B	REVISE GENERAL NOTES; UPDATE TO CURRENT STANDARDS	RF	09.09.30
A	NEW ISSUE	CP	07.07.07
REV.	DESCRIPTION	BY	DATE
DESIGN	97	DART AEROSPACE LTD HAWKESBURY, ONTARIO, CANADA	
DRAWN	RF		
CHECKED	97	DRAWING NO.	REV. B
MFG. APPR.	140	D412-664-249	SHEET 1 OF 4
APPROVED	140	TITLE	SCALE
DE APPR.	140	CROSSTUBE (412 LOW AFT)	NTS
DATE	09.09.30	COPYRIGHT © 2007 BY DART AEROSPACE LTD THIS DOCUMENT IS PRIVATE AND CONFIDENTIAL AND IS SUPPLIED ON THE EXPRESS CONDITION THAT IT IS NOT TO BE USED FOR ANY PURPOSE OR COPIED OR COMMUNICATED TO ANY OTHER PERSON WITHOUT WRITTEN PERMISSION FROM DART AEROSPACE LTD.

DRAWING NO. D412-664-249	TITLE CROSSTUBE ASS'Y (412 LOW AFT)	REV. B	<b>DART AEROSPACE LTD ENGINEERING ORDER</b>		D.E.O. NO. D412-664-249-B-1	SHEET NO. SHEET 1 OF 2	SCALE NTS
DRAWN <i>q</i>	CHECKED <i>Sc</i>	MFG. APPR. <i>R</i>	APPROVED <i>MD</i>		DE APPR. <i>MD</i>		
DATE 11.05.25	DATE 11.05.31	DATE 11.05.31	DATE 11/05/31		DATE 11.05.31

DRAWING NO. D412-664-249	TITLE CROSSTUBE (412 LOW AFT)	REV. B	<b>DART AEROSPACE LTD ENGINEERING ORDER</b>		D.E.O. NO. D412-664-249-B-3	SHEET NO. SHEET 1 OF 3	SCALE NTS
DRAWN <i>97</i>	CHECKED <i>9</i>	MFG. APPR. <i>ND</i>	APPROVED <i>ND</i>		DE APPR. <i>ND</i>		
D

**D412-664-249**  
**ASSEMBLY DETAIL**

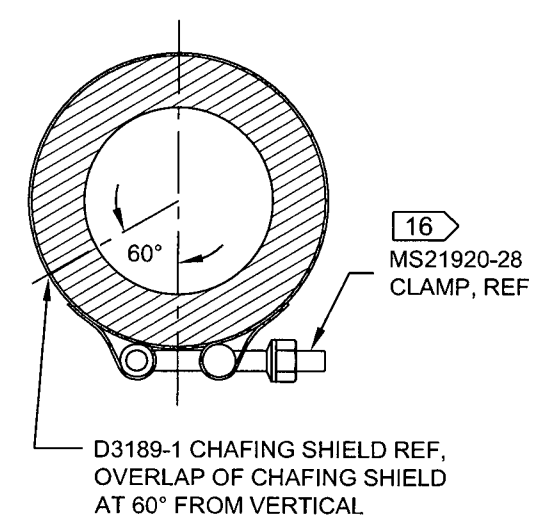
REMOVED ABRASION STRIP IN FAVOR OF A THIN LAYER OF PROSEAL 890.

**IS:**

D3189-1 CHAFING SHIELD (1, INSTALLED OVER PROSEAL 890)  
MS21920-28 CLAMP, 2X  
2 PL

**WAS:**

D2856-600-1009 ABRASION STRIP  
D3189-1 CHAFING SHIELD (1, INSTALLED OVER ABRASION STRIP)  
MS21920-28 CLAMP, 2X  
2 PL

**D412-664-249  
ASSEMBLY DETAIL**

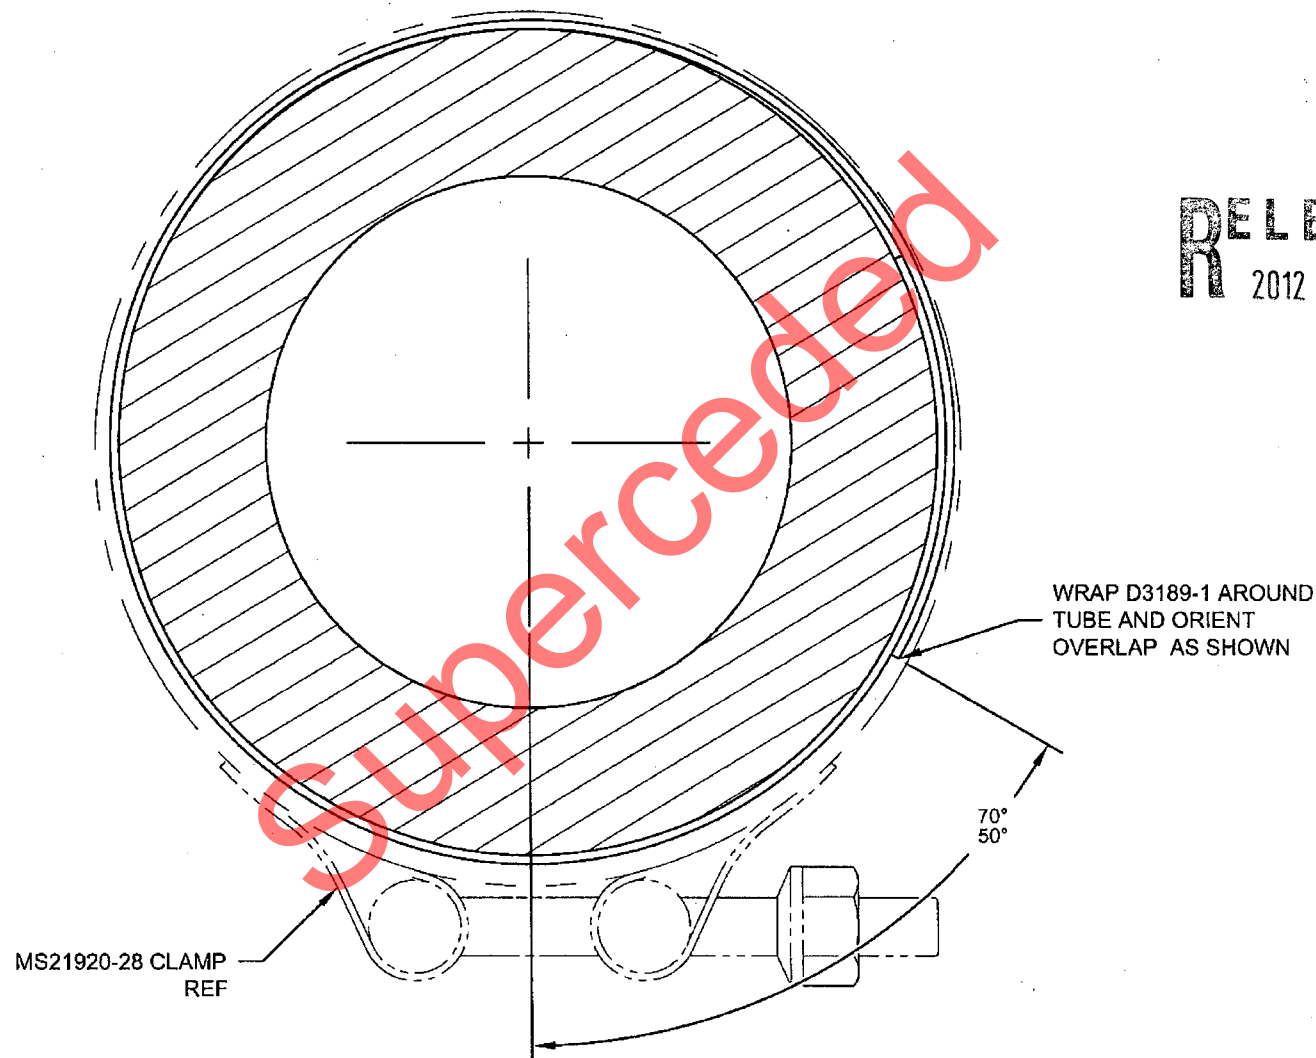
REMOVED ABRASION STRIP IN FAVOR OF A THIN LAYER OF PROSEAL 890. UPDATE INSTALLATION OF CHAFING SHIELDS AND REDUCE TORQUE TO 40-50 IN-LBS. THIS ENGINEERING ORDER SUPERCEDES DEO D412-664-249-B-1

**IS:**

D3189-1 CHAFING SHIELD (1, INSTALLED OVER PROSEAL 890)  
MS21920-28 CLAMP, 2X  
2 PL

11.83  
TO CLAMP

11.60  
TO  
CHAFING  
SHIELD

4.00  
CLAMP SPACING

4.38  
CHAFING SHIELD, REF

**WAS:**

D2856-600-1009 ABRASION STRIP  
D3189-1 CHAFING SHIELD (1, INSTALLED OVER ABRASION STRIP)  
MS21920-28 CLAMP, 2X  
2 PL
